<p>Service Bulletin</p>	File	GB-26-111 (Rev. 1)
	Subject	Connecting Rod Bolts 283 and 310 Cubic Inch Engines
	Date	1-25-85
	Page	1 of 3

THIS BULLETIN SUPERSEDES AND CANCELS SERVICE BULLETIN GB-26-111, DATED 3-25-83.

Fig. 1 Old Connecting Rod Bolts

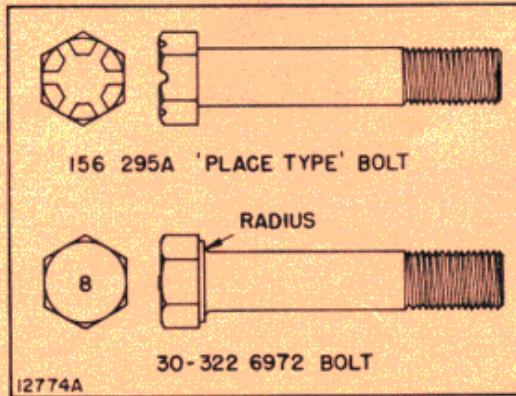
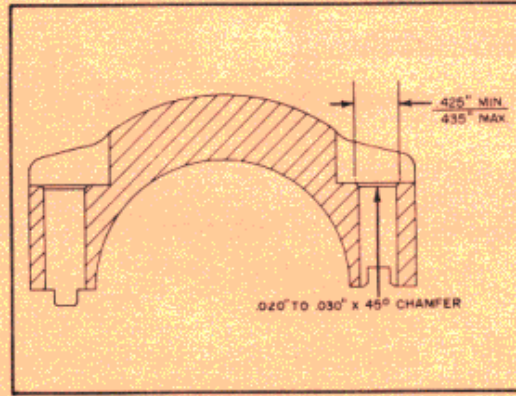
3. Some failures are related to radius on 30-322 6972 Bolt and chamfer in connecting rod cap. (Figures 1 and 2.) Here two situations can exist:
 - 3.1 Rod cap was not chamfered on early engines because of the design of the 156 295A Place Bolt. When 30-322 6972 Bolt is used with this design cap, interference exists and proper clamping action cannot be obtained.

- 3.2 Or, chamfer has been added in the field and is not properly machined either not eliminating the interference, or chamfer is too large which reduces head contact with cap.

1. Adjust high no-load speed to 2550-2600 RPM using an accurate tachometer. Only one turn of adjusting screw means a 150 RPM change in speed.
2. Use 12 new 20-700 2212 12 Point Rod Bolts and 12 new 20-700 2213 Hardened Washers when reassembling engine. (Fig. 3.). These parts are designed to provide proper fit with either a non-chamfered cap or a cap with improper chamfer machining.

Fig. 4 Checking Head Bolt Clearance

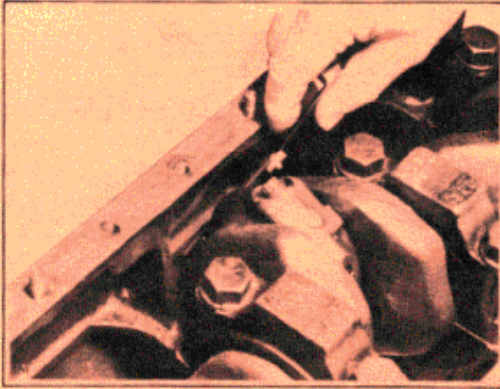
DUE TO CRANKCASE CASTING VARIATION, CHECK CLEARANCE BETWEEN EACH ROD BOLT HEAD AND SIDE OF BLOCK AS SHOWN IN FIGURE 4. THERE MUST BE AT LEAST 0.060 INCH CLEARANCE. IF THERE IS NOT, GRIND PORTION OF BOLT HEAD AWAY TO PROVIDE THIS CLEARANCE. (Fig. 5.)
